**PRELIMINARY DRAINAGE REPORT
FOR
7TH DAY ADVENTIST – SCOTTSDALE & SUTTON**

November 26, 2019
WP# 194966

Case Review – Seventh Day Adventist Rezoning

PROJECT NAME: SEVENTH DAY ADVENTIST REZONING
LOCATION: NWC OF SCOTTSDALE ROAD AND SUTTON DRIVE
CASE NUMBER: 14-ZN-2019

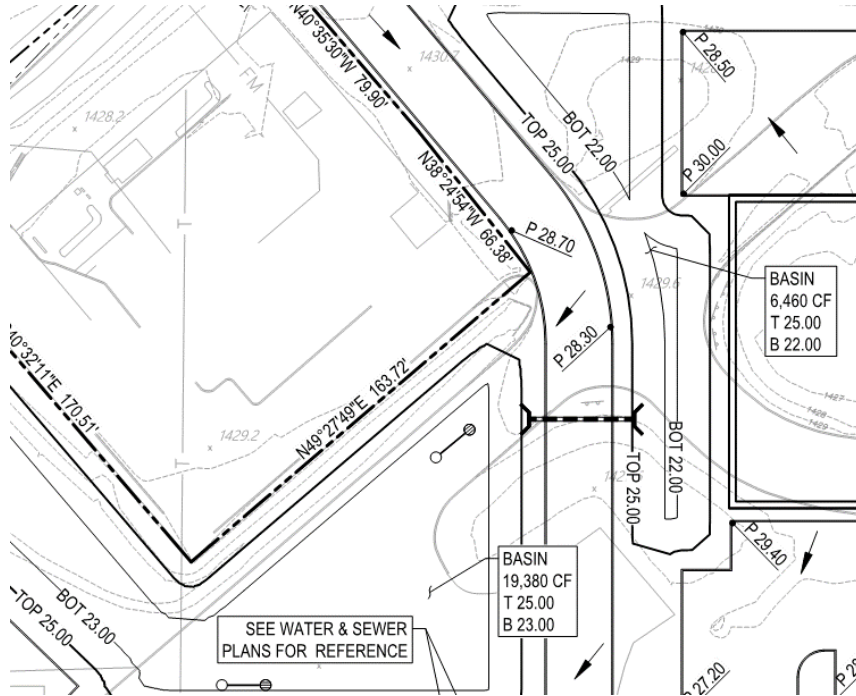
1. 1st Review: The Preliminary Drainage Report states that “no offsite flows appear to impact the Site.” Based on available existing topo, it appears that the northeast corner of the site is impacted by offsite flow. Address this in the drainage report.

2nd Review: This comment has only been partially addressed. The report has been revised to acknowledge offsite flow, however this offsite flow is neither quantified or addressed in the conceptual drainage design. This will need to be addressed as a stipulation to provide detailed analysis. (AOM 12/23/2019)

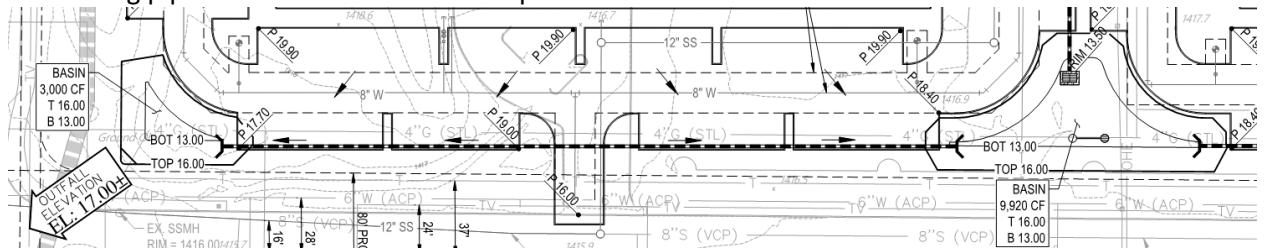
4. Some proposed stormwater basins do not have a means to drain by gravity. For example, as shown below, the basin with a bottom elevation of 23.0 has a proposed drywell; however, the basin with a lower bottom of 22.0 has no means to drain.

In the following example, the basin to the west is intended to be equalized with the basin to the east, which is to drain via drywell. However, in order to drain properly and avoid standing water, the basin to the west should have a bottom that is almost two feet higher so that the approximately 360-ft long connecting pipe will have the minimum slope of 0.5% to drain.

2nd Review: This comment has not been addressed. This will need to be addressed as a stipulation. (AOM 12/23/2019)
